RAI 03.07.02-24, Supplement 1, Revision 1**QUESTION:****Follow-up Question to RAI 03.07.02-15 (STP-NRC-100036)**

RAI 03.08.01-9, Revision 2**QUESTION:****Follow-up to Question 03.08.01-6**

RAI 03.08.04-17, Supplement 1**QUESTION:****Follow-up to Question 03.08.04-1 (RAI 2964)**

RAI 03.08.04-28, Revision 1**QUESTION:****Follow-up to Question 03.08.04-19**

Figure 3H.7-2: Dynamic At-Rest Lateral Earth Pressure (psf) on the Walls of the Fuel Oil Tunnel DGFOT Walls

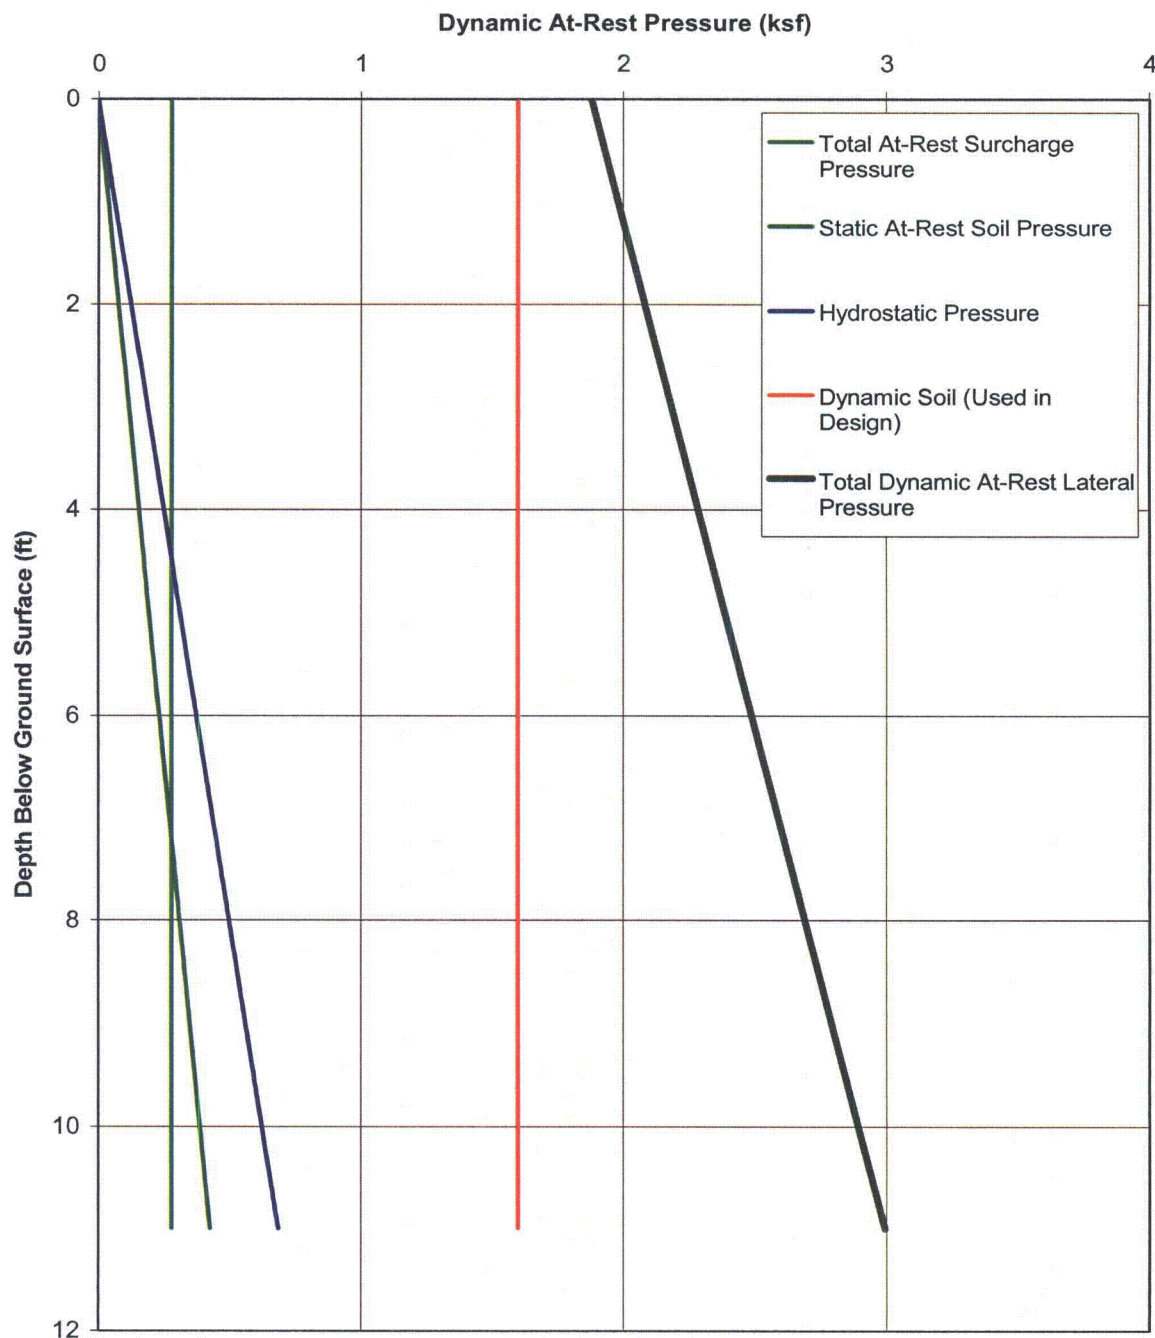
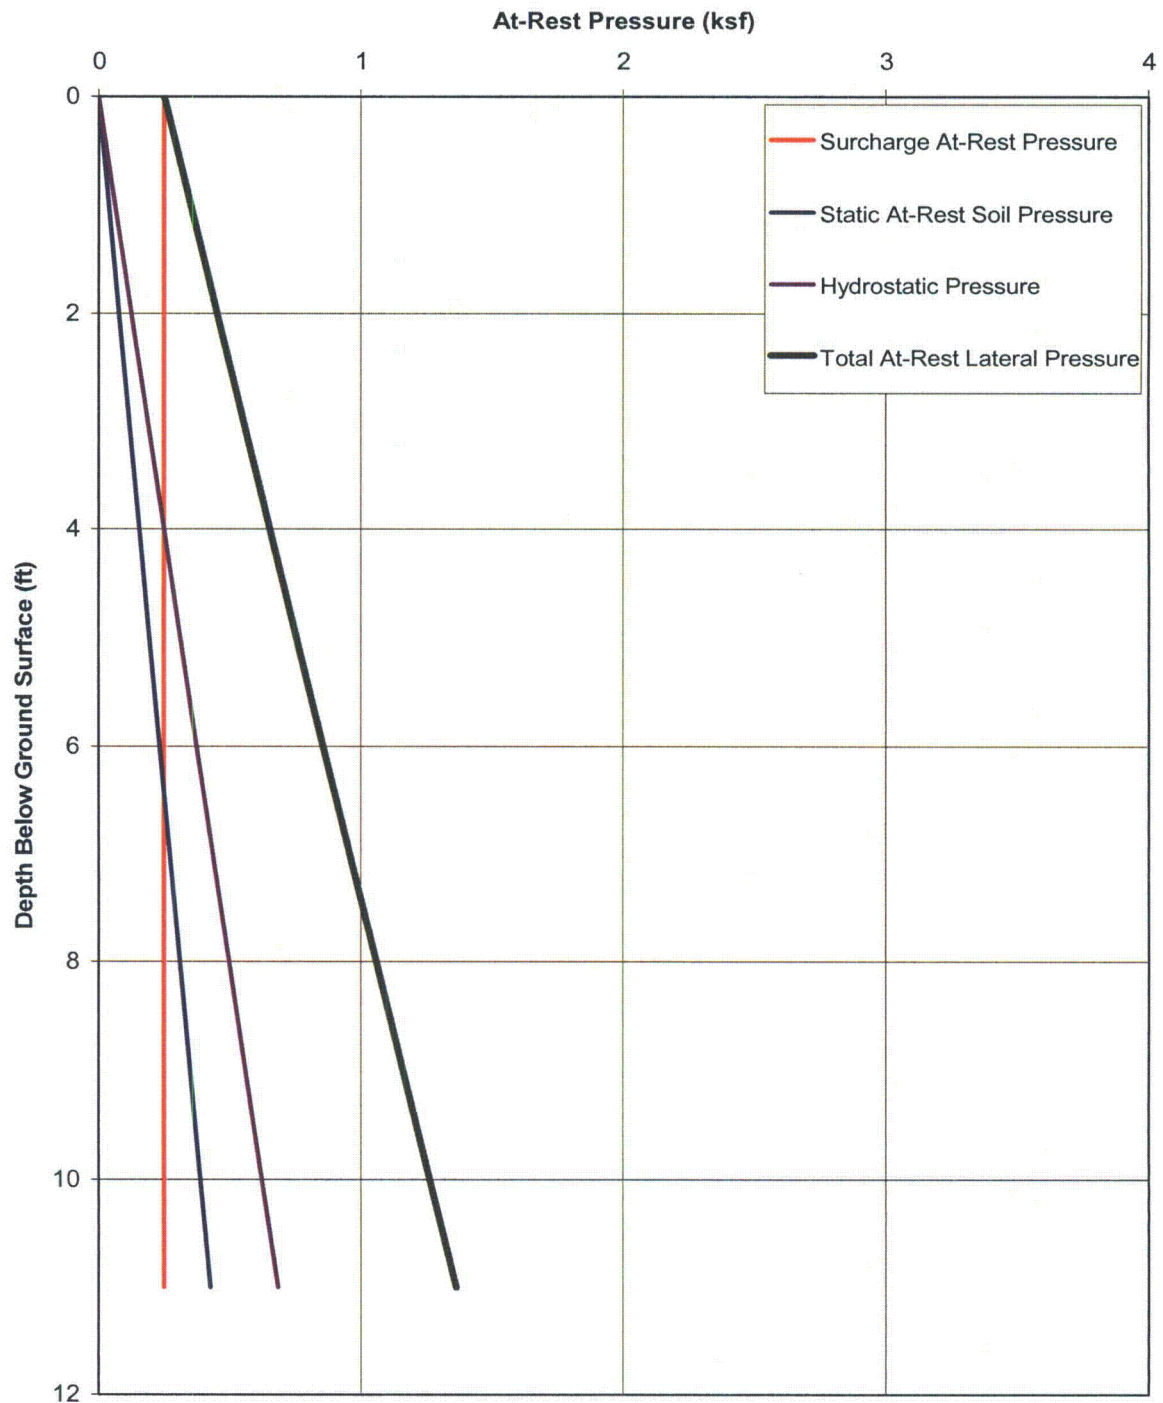
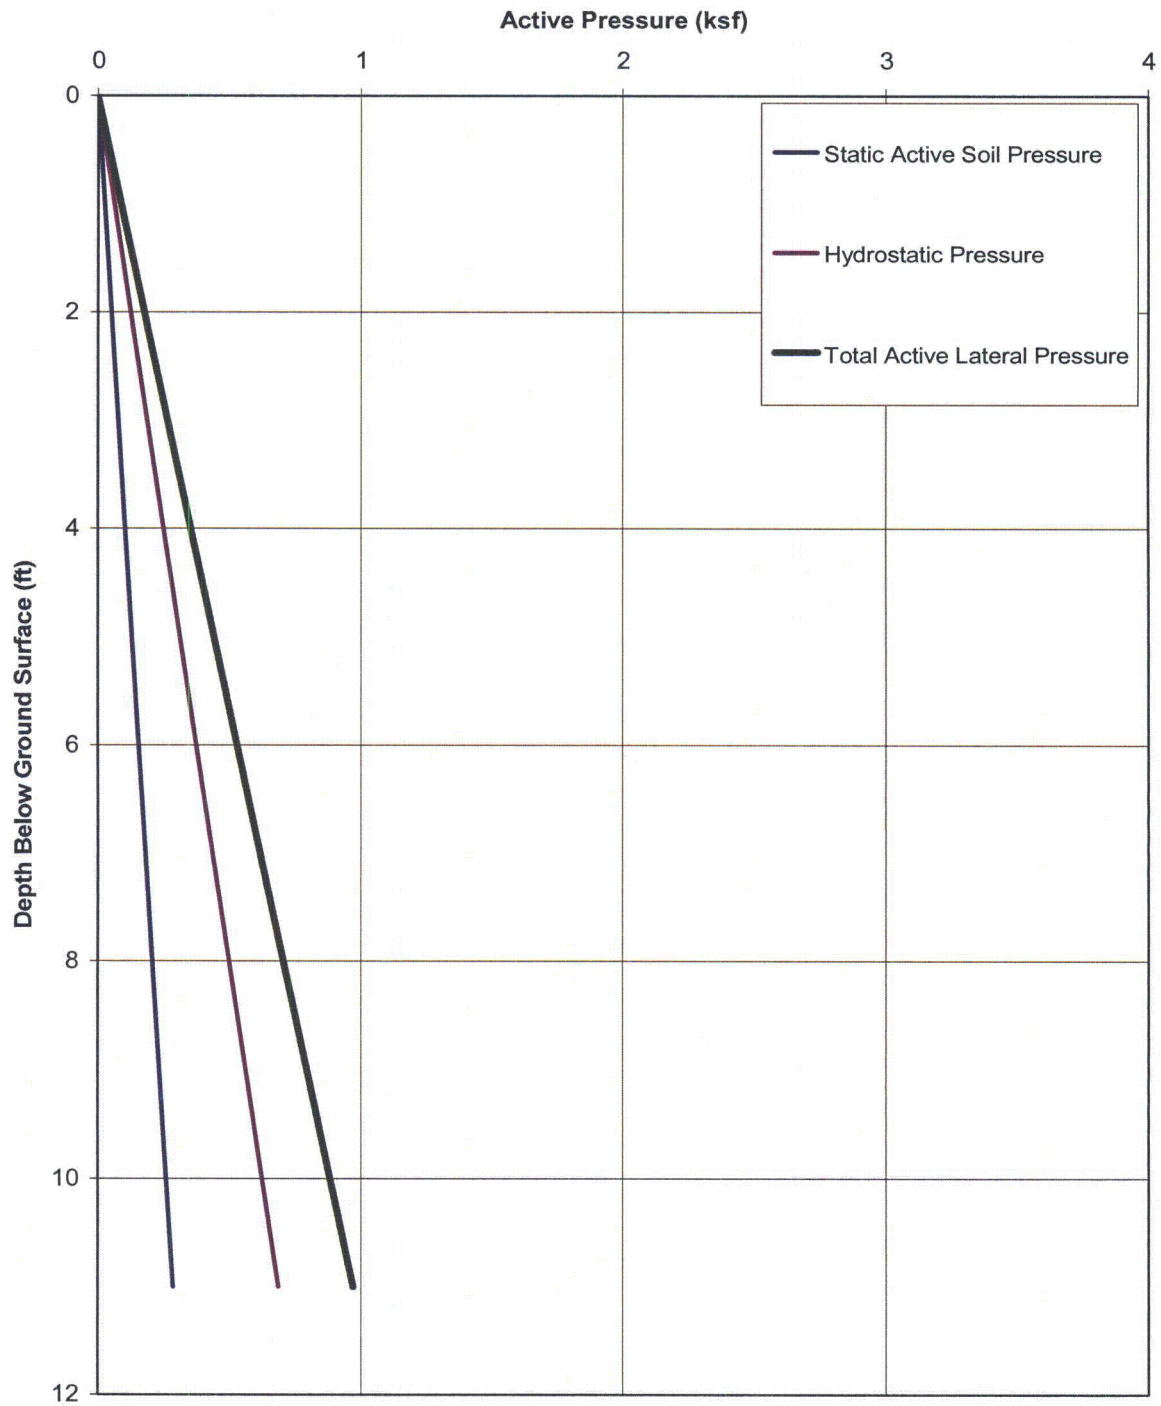
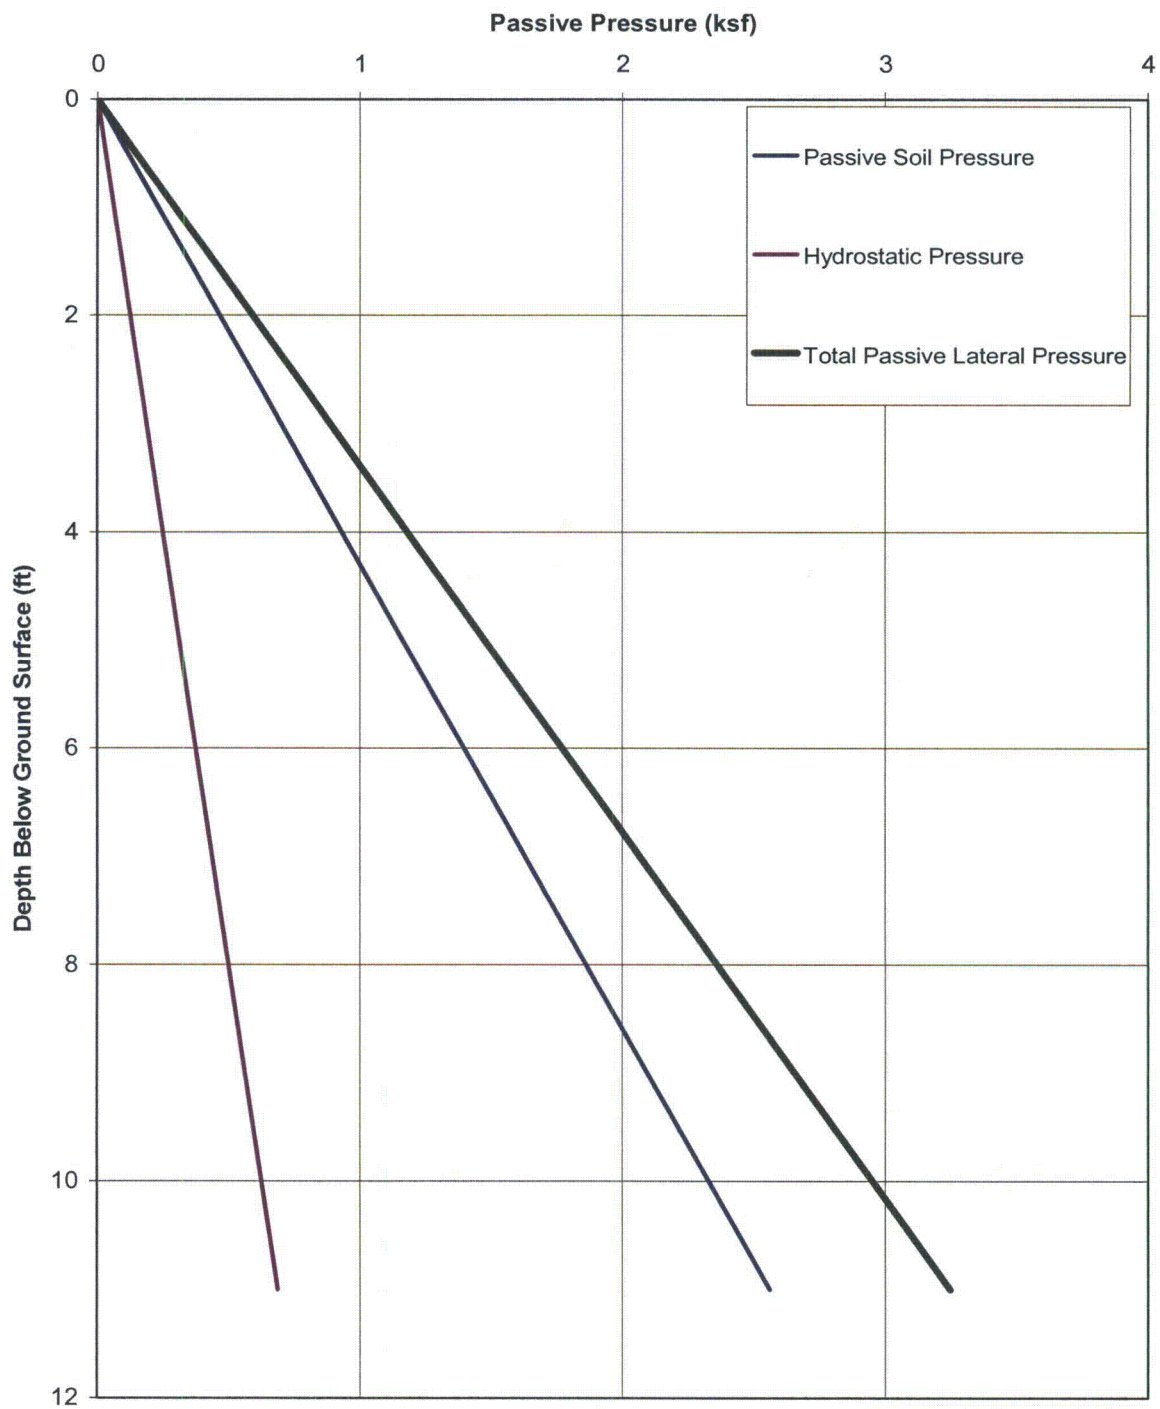
- b) For the staff to conclude that the design of structures with deep foundations, such as the Reactor Building (RB) and Control Building (CB), is satisfactory for the site, the site-specific design loads are needed to compare with the design loads used for the DCD. Lateral soil pressure is one such load. Therefore, please provide the lateral soil pressures for the RB and the CB, and compare these calculated pressures with those used in the ABWR standard plant design. Please also confirm if the effects of adjacent structures are considered in computing the lateral soil pressures, and if not, provide the justification for not doing so.

The SSSI incremental seismic soil pressure curves for the standard plant Diesel Generator Fuel Oil Tunnel (DGFOT) have been provided in COLA Part 2, Tier 2, Figures 3H.7-5 through 3H.7-8, in the response to RAI 03.08.04-30, submitted with STPNOC letter U7-C-STP-NRC-110008, dated January 17, 2011. The at-rest, dynamic at-rest, active and passive soil pressure profiles are provided in Figures 3H.7-2 and 3H.7-33 through 3H.7-35, included in Enclosure 2 of this response.
